Subject: MICE Committee Recommendations

MICE Spectrometer Meeting

Spectrometer Magnet Heat Load

MICE Spectrometer Solenoid 2B Issues

Fig. 1 Magnet 2 burned out HTS lead.

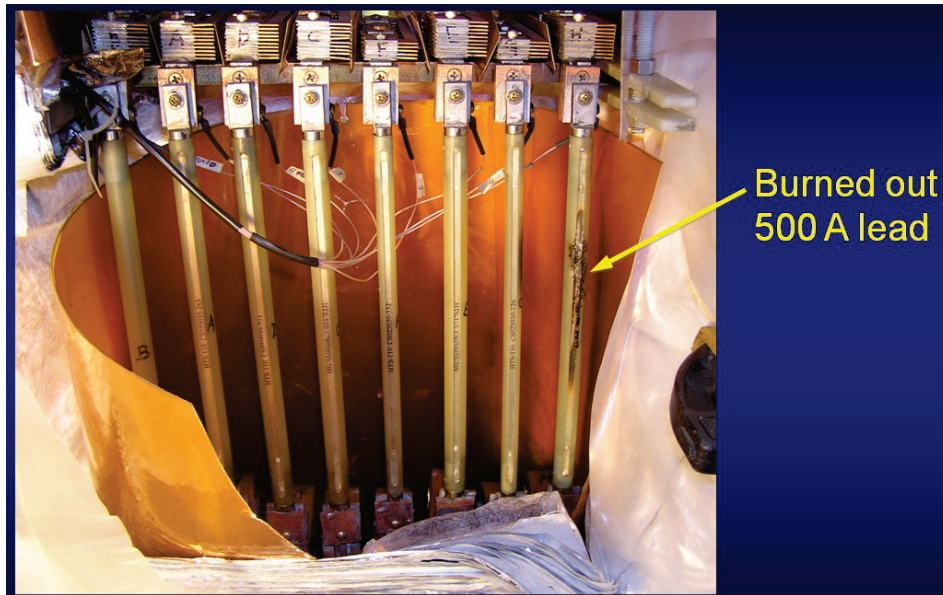
- Burned HTS current lead (See Fig. 1) at 238 A current and 81K leads temperature [11].
- Coil M2 open circuit after the 257 A quench.

Regarding the first item above, after modifications the solenoid 2B was successfully cooled down to 4.5 K, the helium vessel filled with LHe, and HTS leads were operated at reasonable temperature, 50 K. Nevertheless, additional losses during quench could overheat HTS current leads, and busses. These areas should be properly modeled and investigated to avoid potential future HTS lead failures.

Fig. 7. Upper and HTS leads configuration.

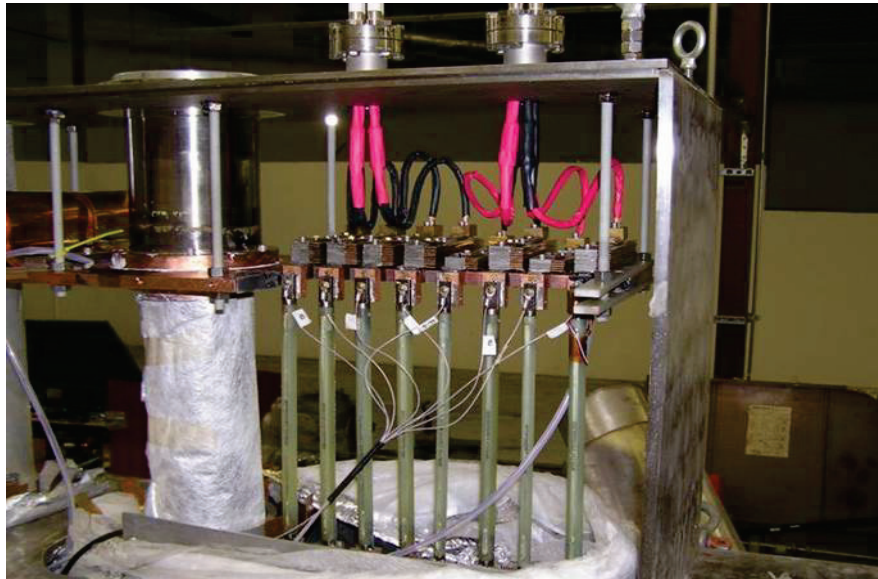
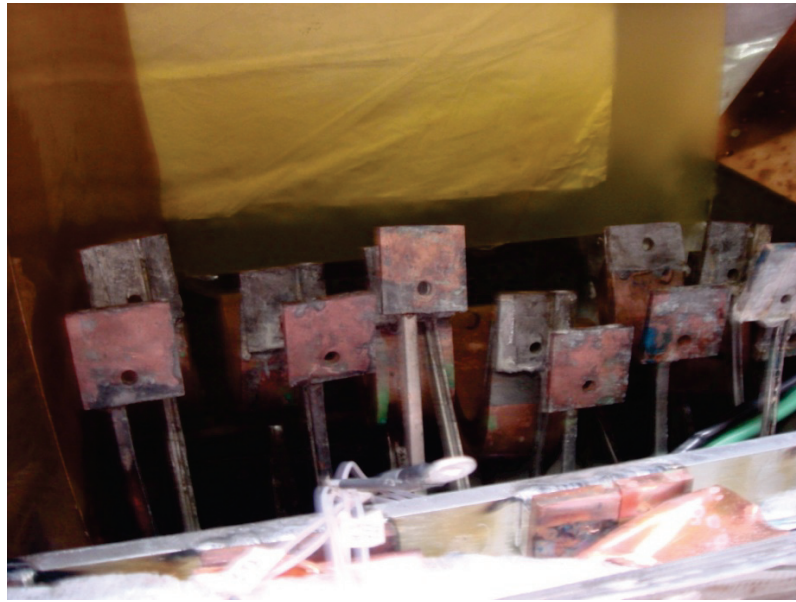
The steady state magnetic field analysis showed that the calculated peak fields are in agreement with the MICE documentation. Nevertheless, it should be noted that manner in which the current leads were installed does not necessarily result in the position of the leads being fully known after cooldown (See. Fig. 7, Fig. 8).

In addition the cold mass axis position was not absolutely fixed during assembly, there is some chance that it could deviate from the outer vacuum vessel axis. Between the two effects, there is some chance the HTS current leads could catch substantial perpendicular field component which will reduce the lead performance (See Fig. 9). This field also could generate circulating currents in the HTS which will additionally heat up these leads during ramping. A more complete analysis and assembly plan should be completed to better understand the position of the leads. If warranted, the addition of a ferromagnetic shield around these current leads will eliminate this effect.

Fig. 9 HTS-110 current factor vs. field and temperature.

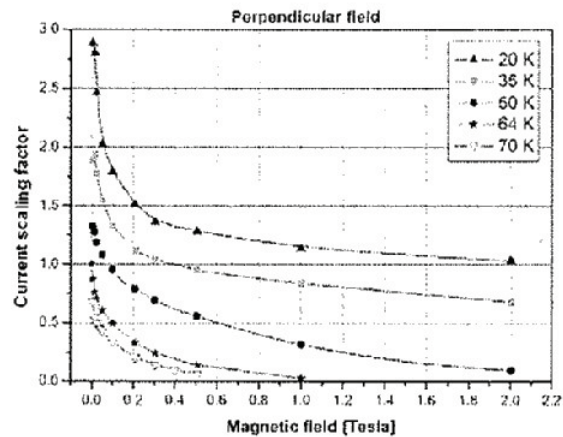
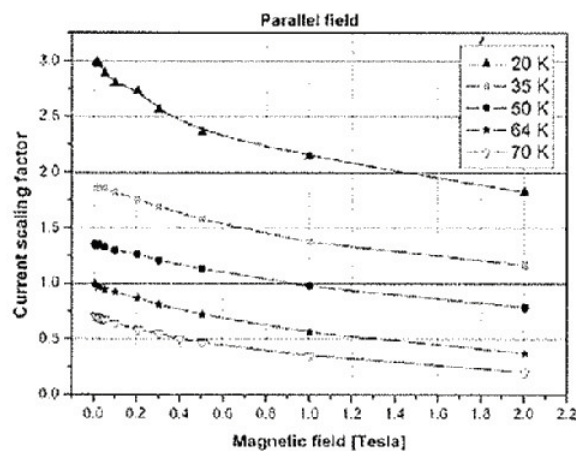
The HTS-110 current lead is capable of carrying, without external magnetic field, 500 A at 65K measured at the warm end.

Fig. 11 Cold feedthrough view.

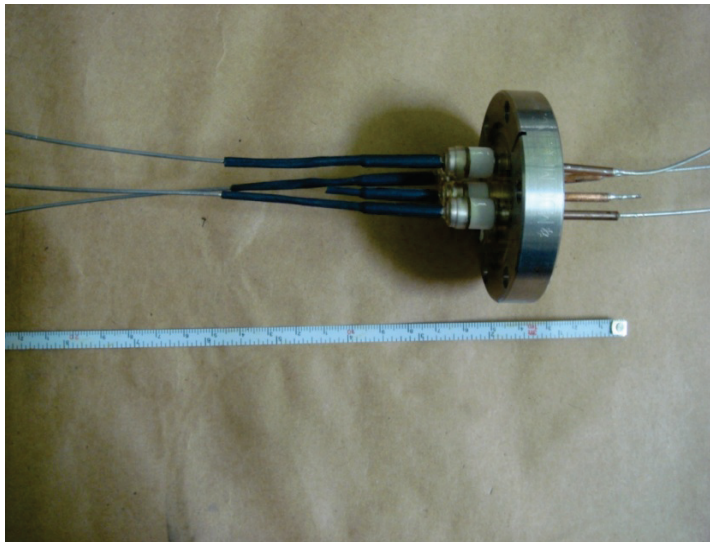
Our calculation showed that the field in the cold feedthrough area is less than 0.1 T (See Fig. 10). In this area there should not be any noticeable Lorentz forces and the field influence on the superconductor performance, even without further stabilization, should not be significant (See Fig. 11).

The superconducting wire on right side of the feedthrough was not additionally stabilized because of limited access to this area during assembly. This area may overheat during a quench.

- If the failure is between the shunt resistor and the feedthrough, Improve the cold feedthrough area and other areas with a single superconductor strand by adding extra copper stabilization;
- If the failure is between the shunt resistor and the coil, the quench protection system should be completely reanalyzed and the modified such that the coils are adequately protected. This could include the introduction of an active quench protection system, or re-optimization of the shunt resistors, for example. Further stabilization of the superconductor strand near the feed through is probably a safe modification in this case as well.
-

Fig. 12 Coil currents after the quench of the central coil.

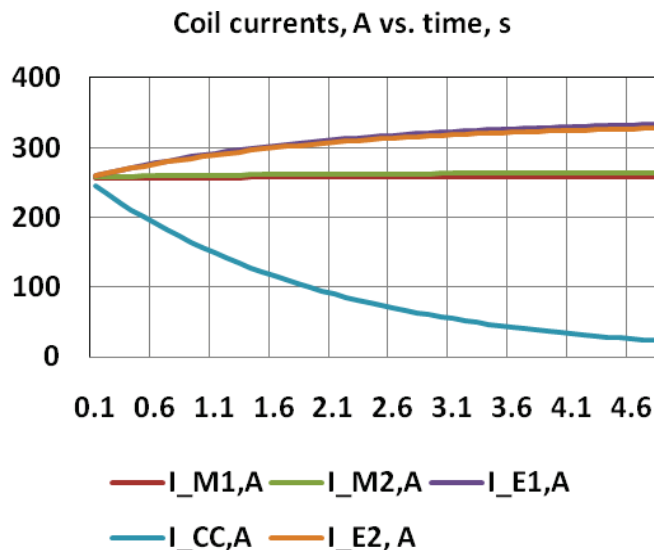
One can see that after the quench the current in the central coil decays from 257 A to $I_{CC} = 20$ A after about 5s. But in all the other coils, the currents increase up to: $I_{M1} = 258$ A, $I_{M2} = 264$ A, $I_{E1} = 334$ A, $I_{E2} = 328$ A. Even for the M2 coil which has the lowest inductance, the time constant for the current to decay via the 20 m Ω shunt resistor is 250 s.

Fig. 14 Aluminum mandrel temperature rise vs. time under the coil centers.

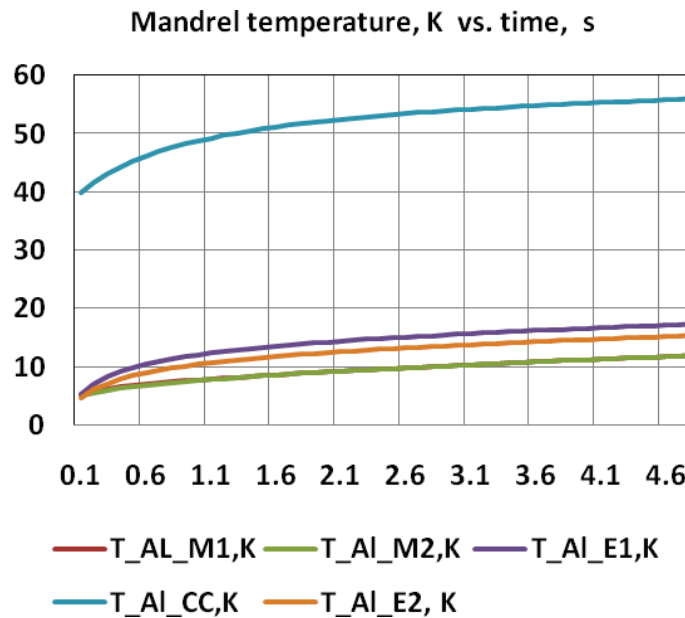
The critical current for the E1 and E2 coils is around 370 A. A quench in these coils which should only occur at fields of 5.4 T and 5.8 T, respectively, (See Fig. 4) may happened because due to training and thus may occur at lower currents. A coil current of 264 A in the M2 coil corresponds to a field of 3.6 T, which is far away from the critical value of 480 A. Only a “quench back” effect from the aluminum mandrel or coil leads heated by a shunt resistor could transfer the coil M2 into a normal condition. In this situation only a transient thermal analysis can help estimate the time of quench in the M2 coil.

Fig. 15 Coil temperature rise during quench because of mandrel heating.

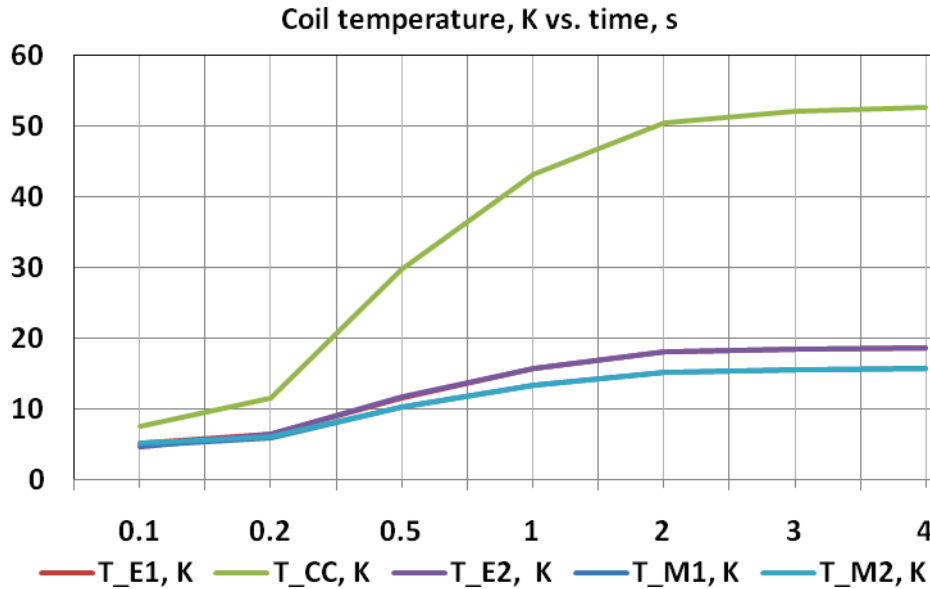
Because the induced current in the mandrel is concentrated under the quenched central coil CC, the central coil is heated to 50 K after 2 s. This is in an addition to any resistive coil heating. The time of the other coil quenches is the sum of the Al mandrel heating time and the heat transfer from mandrel to the coil. Coils E1 and E2 will be quenched after ~ 1.5 s. Coils M1 and

M2 will see “quench back” effect after ~ 2.2 s. If the real thickness of ground insulation is larger than 1 mm, this delay will be even larger due to the additional thermal resistance of the insulation layer. Fig. 15 shows the coil temperatures at different times. It should be noted that power losses in the mandrel during magnet charging with rate of 0.06 A/s is only 0.065 W and does not produce substantial additional heat load. In [5] these losses were estimated at 0.036 W and the AC superconductor hysteresis losses at 1.01 W during the solenoid charge time 4620 s.

- Make a full quench analysis covering the test and operating scenarios. The model must include the real solenoid geometry and material properties;
- Modify the test procedure so all coils are not connected in series for training;
- Consider lower risk solenoid training. For example initially train coils M1 and M2. After that E1, E2, CC with coils M1-M2 powered from a separate power supply at the peak current achieved during training for M1-M2. In this case the M1-M2 circuit will have a small current-field margin and will be quenched almost simultaneously with E1-CC-E2.
